RE: WHITEHAVEN SOLAR FARM – RESPONSE TO REQUESTS FOR ADDITIONAL INFORMATION

2.1.2 RFI Dated 13 August 2025

Filename: 22302CAD002-250916 Swept Path Analysis.dwg Date: 16 September 2025

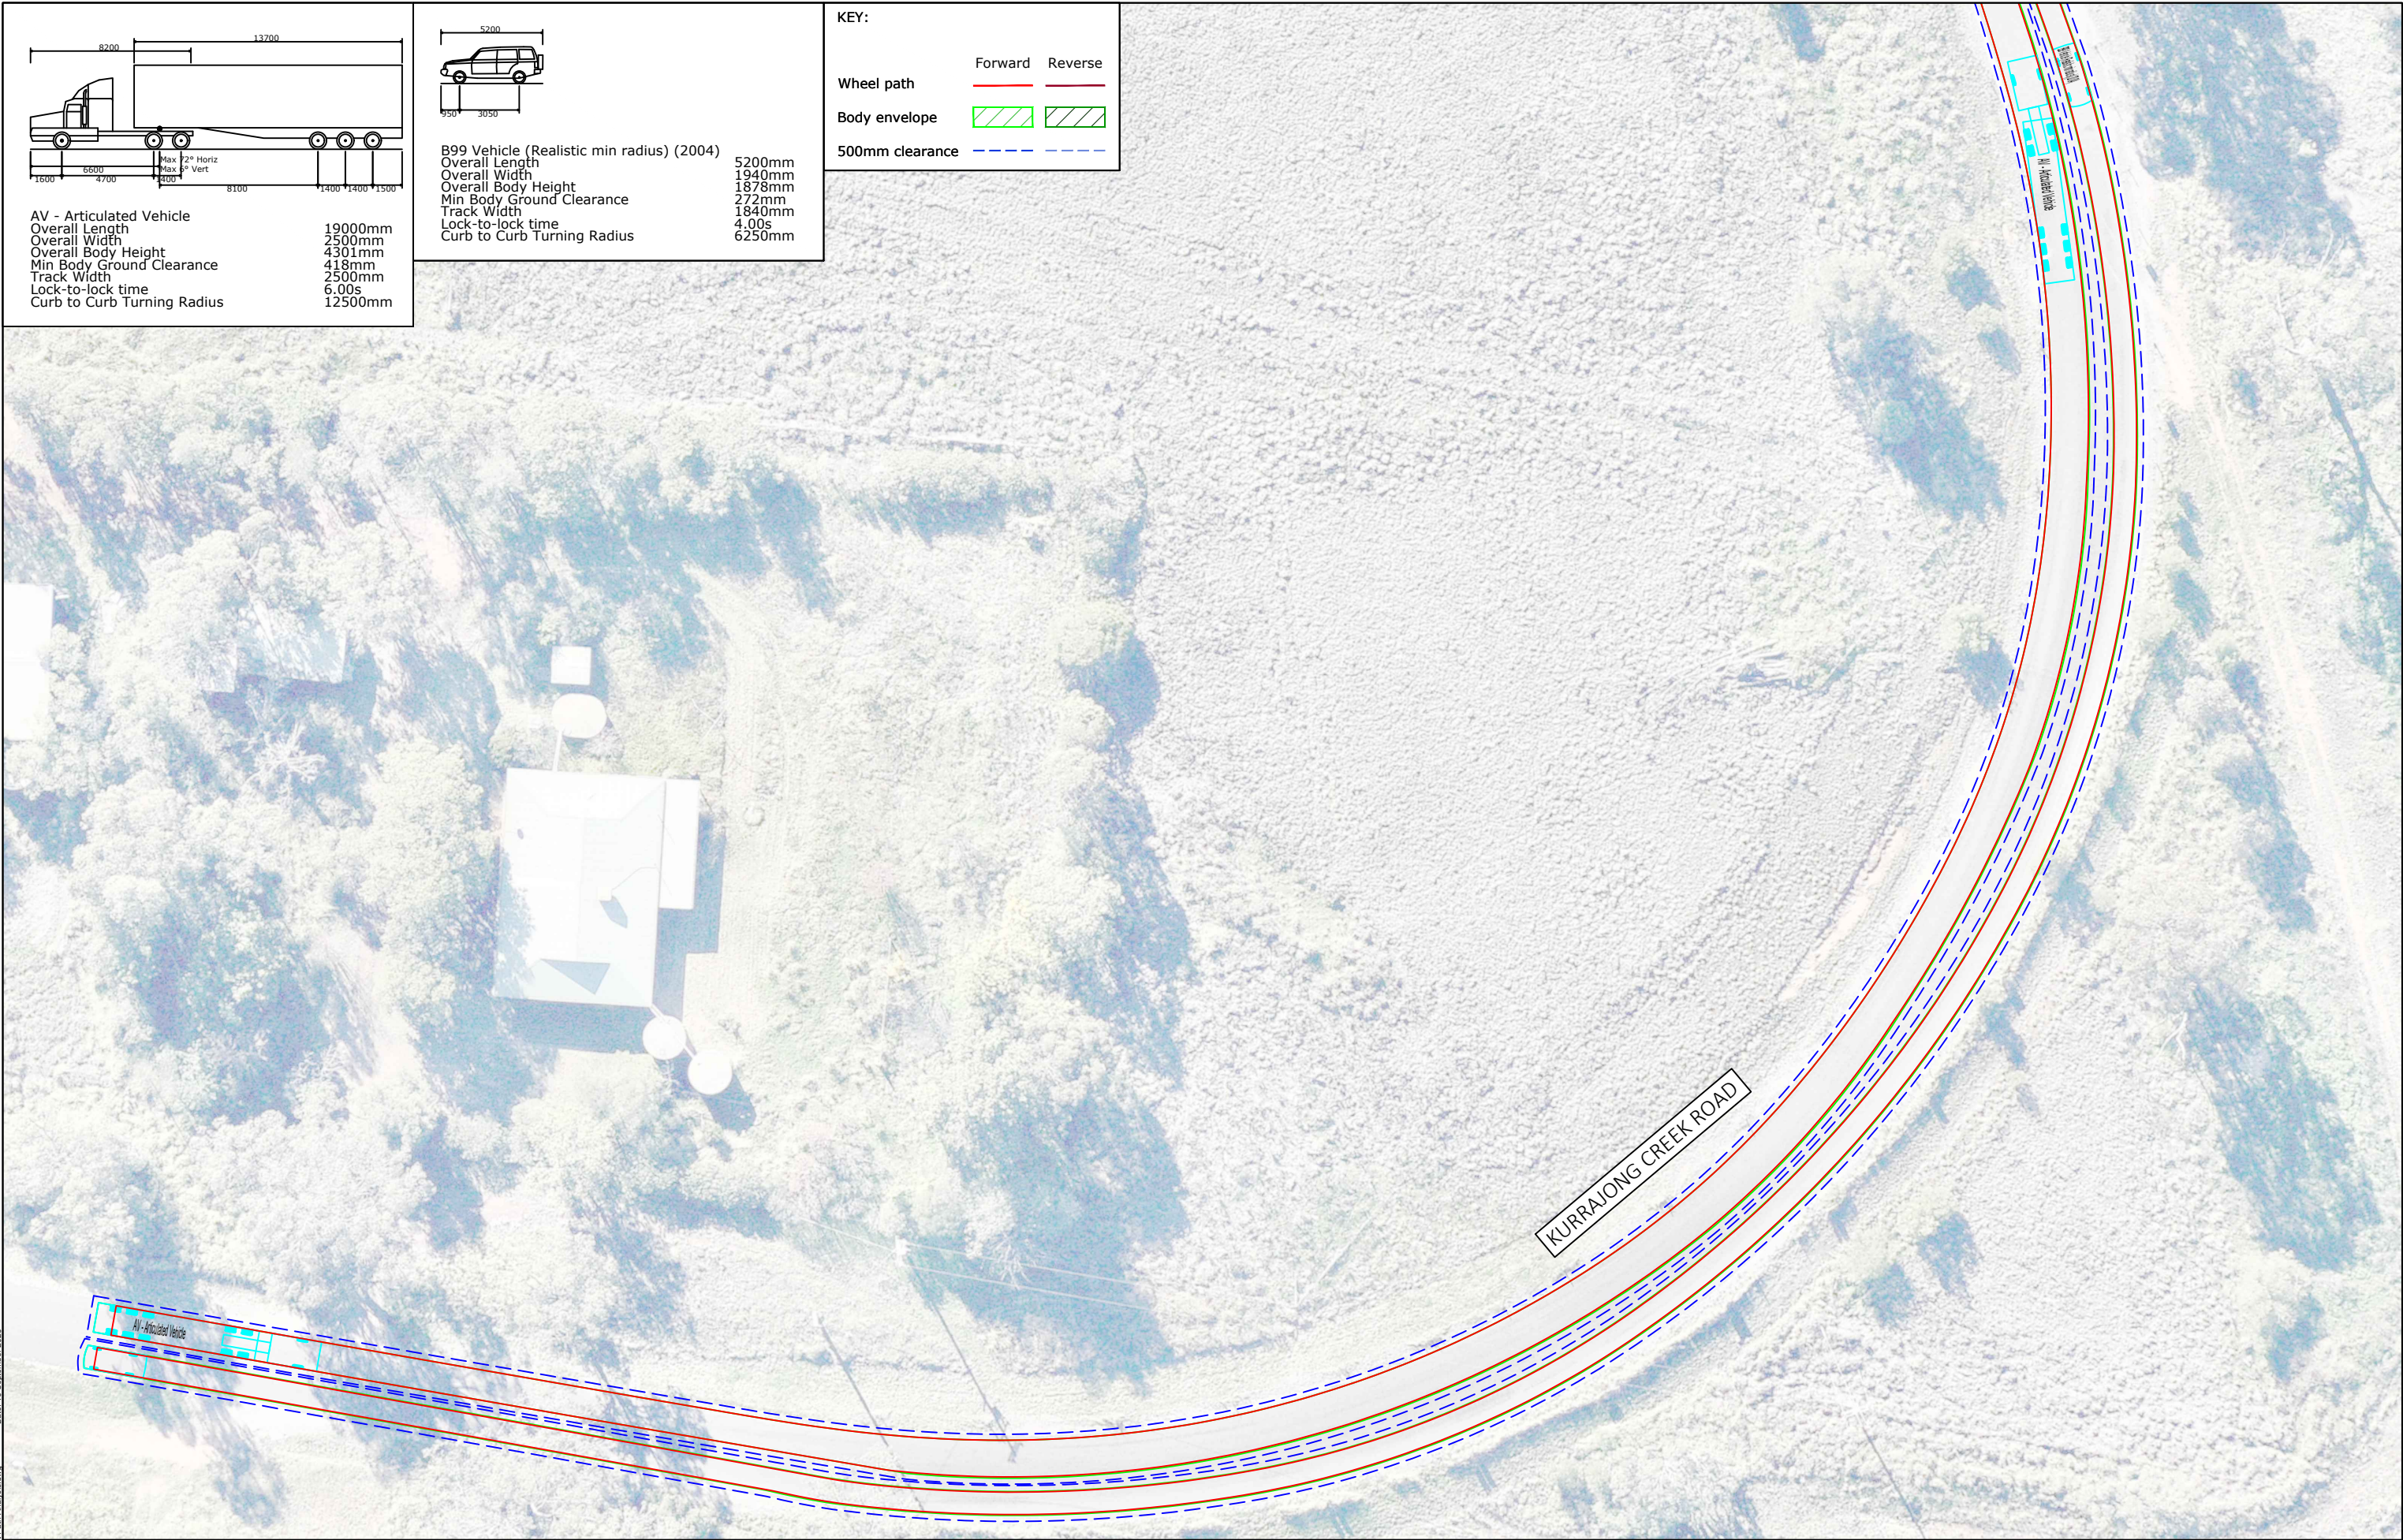
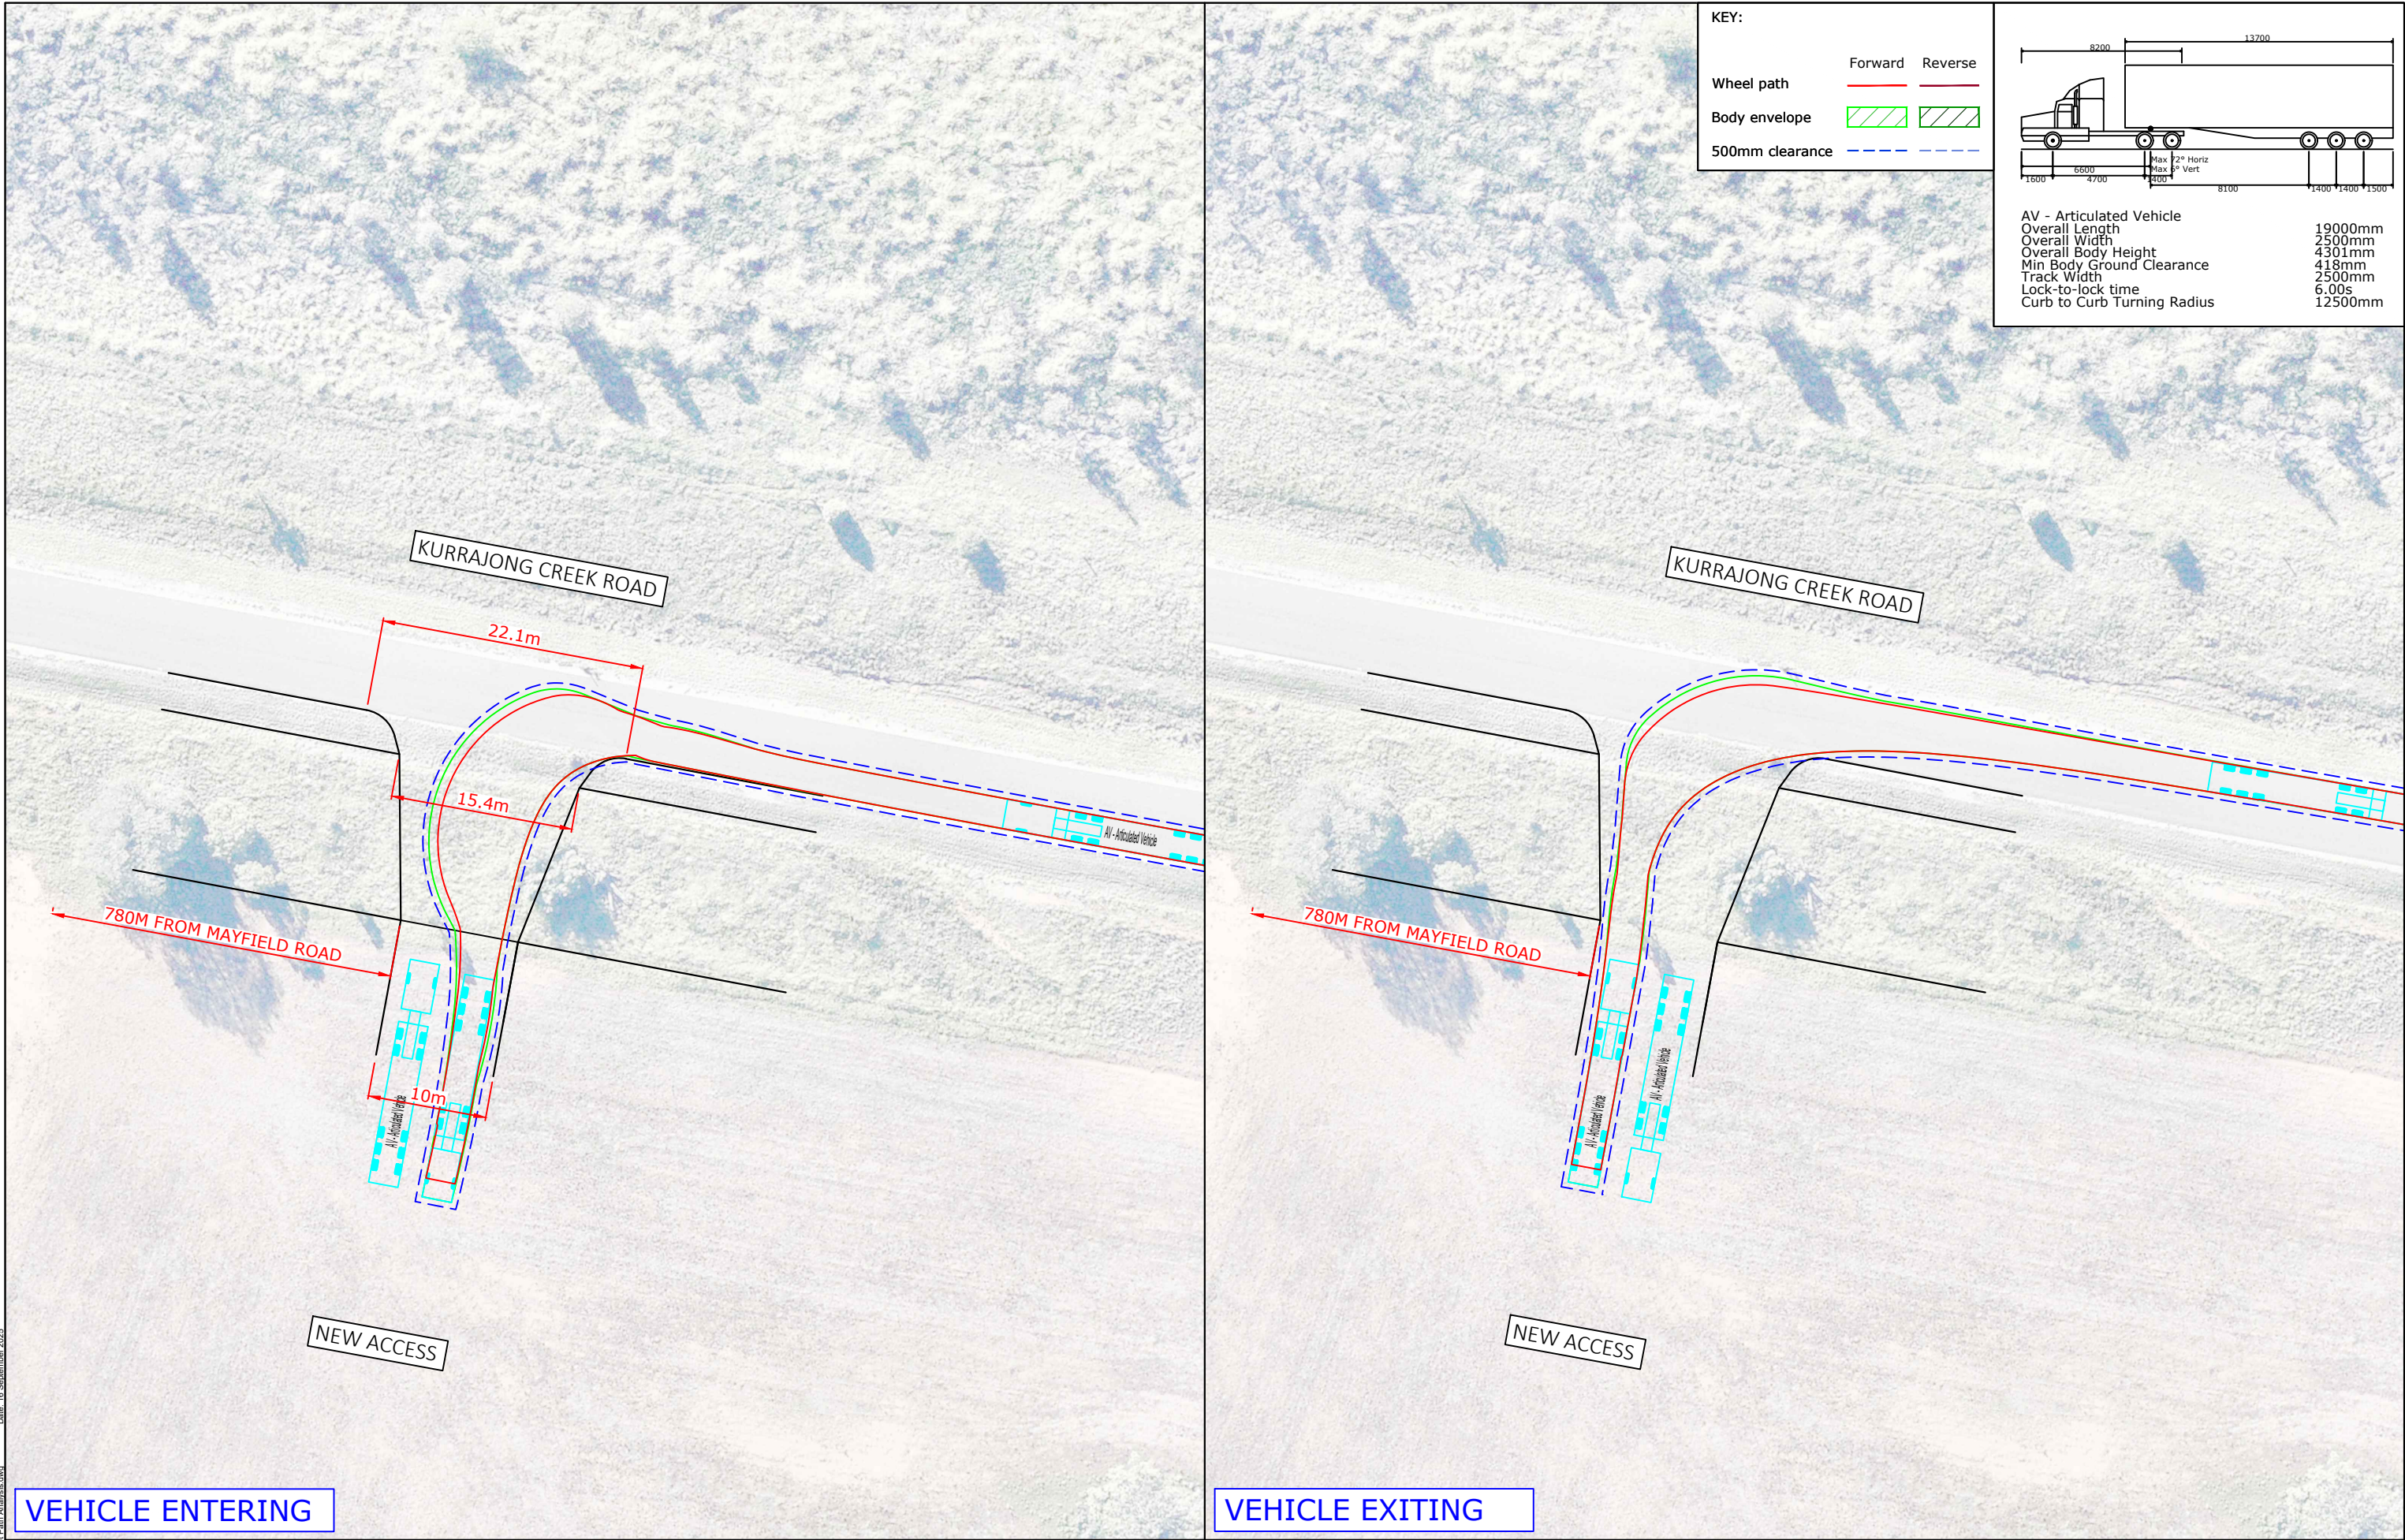
Comment/Recommendation

Please refer to Attachment 2 for the swept path analysis of the design vehicle (prepared by The Transport Planning Partnership). The analysis shows that the design vehicle can turn on the existing pavement at the relevant intersections.
